TOWN OF PARADISE VALLEY

Discussion of Statement of Direction
Andaz Resort Intermediate Special Use Permit Amendment
6160 N Scottsdale Rd & 6041 N Quail Run Rd
Town Council
Work Study

September 8, 2022

GUEST UNIT POOLS & FENCE WALLS

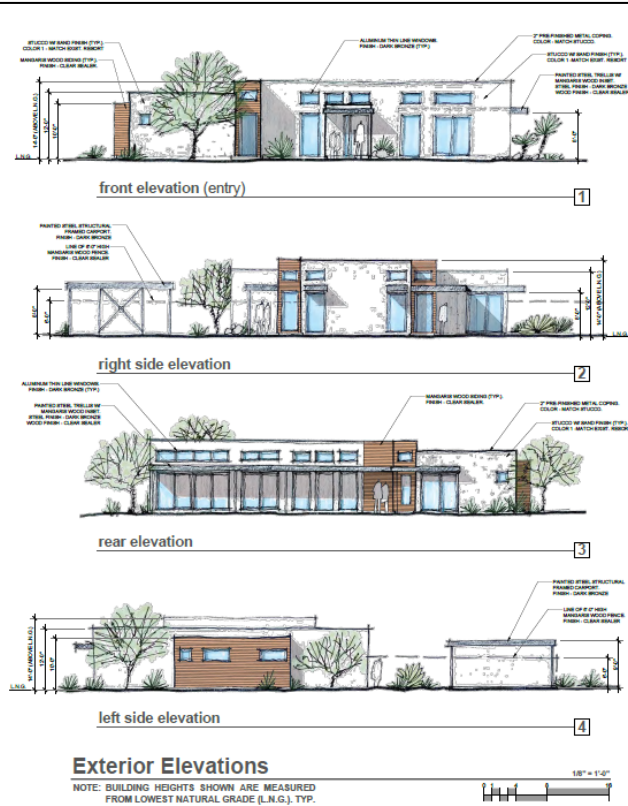
2. Evaluate location and setbacks of new guest units/carports and evaluate location, setback, and heights of new fence walls:
 - a. Guest units setback minimum of 100' from south property line and minimum setback of 40' from post dedication property line adjoining Quail Run Rd. 40' setback requirement from Quail Run Rd post dedication property line is less than 100' setback recommended by SUP Guidelines but compliant with primary residence rear yard setback for R-43 zoning district.

- b. SUP Guidelines recommended fences meet residential fence walls standards in Article 24 of ZO. Western fence wall and portions of internal "yard" walls adjoining Quail Run Rd not compliant with standards in Article 24; which identifies 6' tall meandering fence wall shall meander between 10' and 20' setback lines with average setback of 15'. Proposed fence has slight meander with much of fence on the western property line (0' setback) and portions of wall setback 6' to 14' from property line. Also, many internal yard walls connect to perimeter fence at western property line.

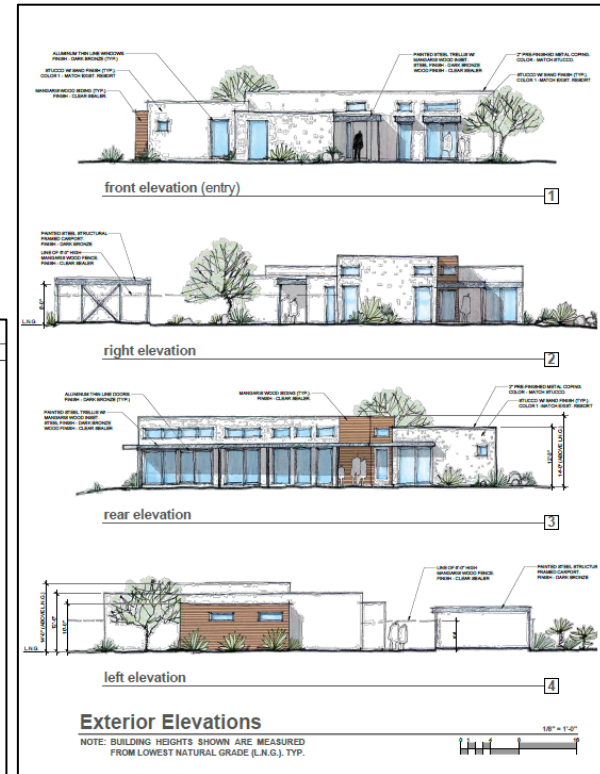
6. Resort entrance will remain the same from Scottsdale Road and guest units will not be accessible from Quail Run Rd.

New 24' wide drive aisle/roadway will connect to existing resort to provide access to 10 new guest units. Commission shall evaluate Trip Generation Report and applicant must provide preliminary paving plans of internal drive aisle/roadway for PC review.

Also, resort currently has 278 parking spaces on site and each guest unit will have a 2-car detached carport; which is compliant with SUP Guidelines. PC may require a Parking Analysis if necessary.
